BUFFALO BAYOU AND TRIBUTARIES, TEXAS

A CORPS OF ENGINEERS REPORT ON BUFFALO BAYOU AND TRIBU-  
TARIES, TEXAS, IN PARTIAL RESPONSE TO A RESOLUTION OF THE  
HOUSE COMMITTEE ON PUBLIC WORKS ADOPTED APRIL 20, 1948

SEPTEMBER 7, 1979.—Referred to the Committee on Public Works and Transportation  
and ordered to be printed

FIGURE 4  
 RESERVOIR AND CHANNEL IMPROVEMENT ALTERNATE PLAN

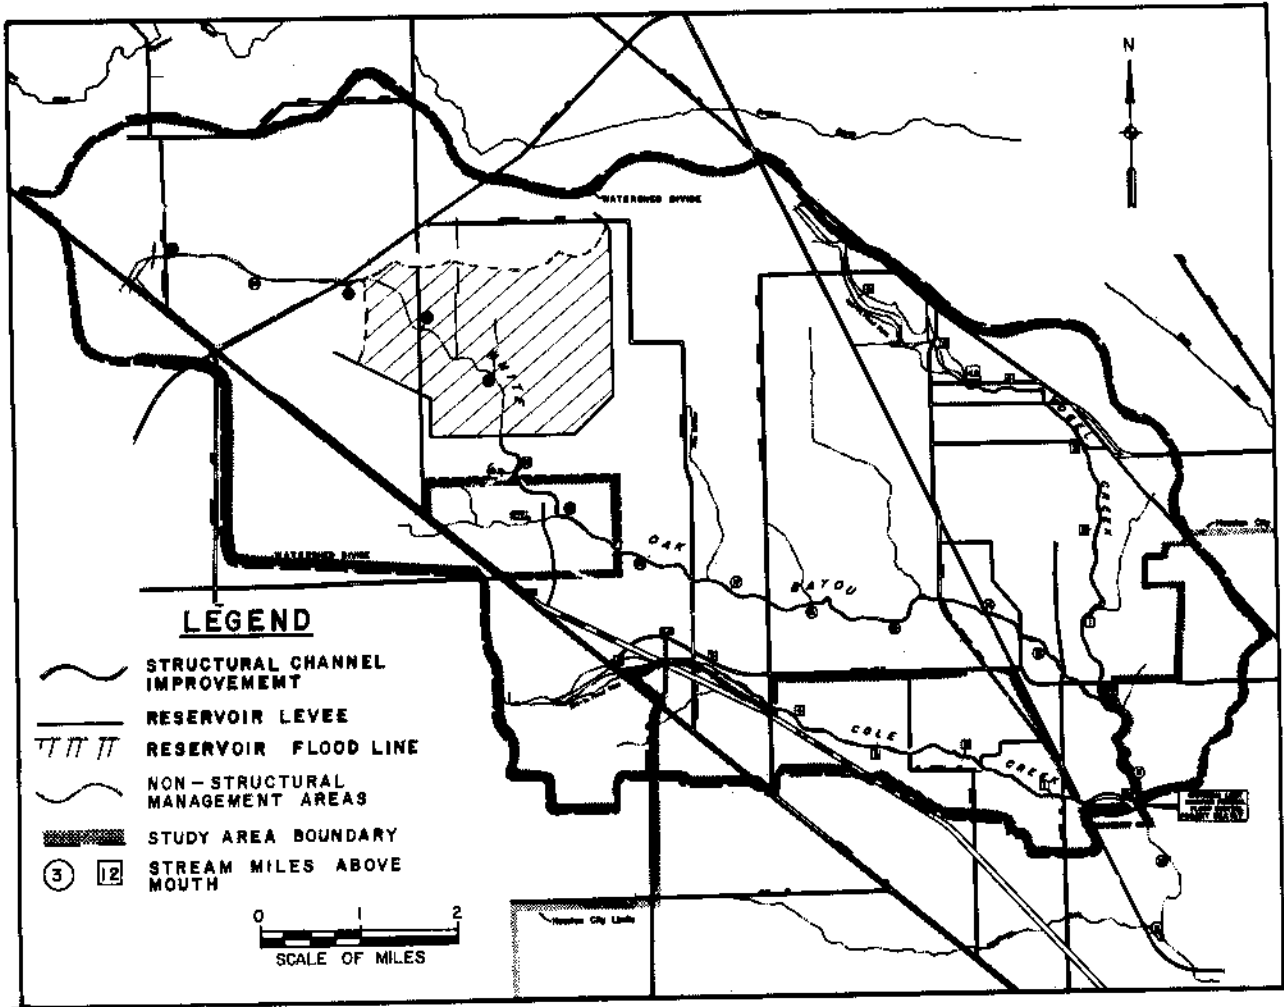
Page 28, Paragraph 6.07. The alternative of diverting water to Addicks Reservoir would compound flooding problems on Buffalo Bayou. This paragraph does not explain why water flowing down White Oak Bayou to Buffalo Bayou would not be a problem, but water diverted to a flood-control reservoir (Addicks) would be a problem. A summary of the explanation on page 42 of the Interim Report on Upper White Oak Bayou should be used.
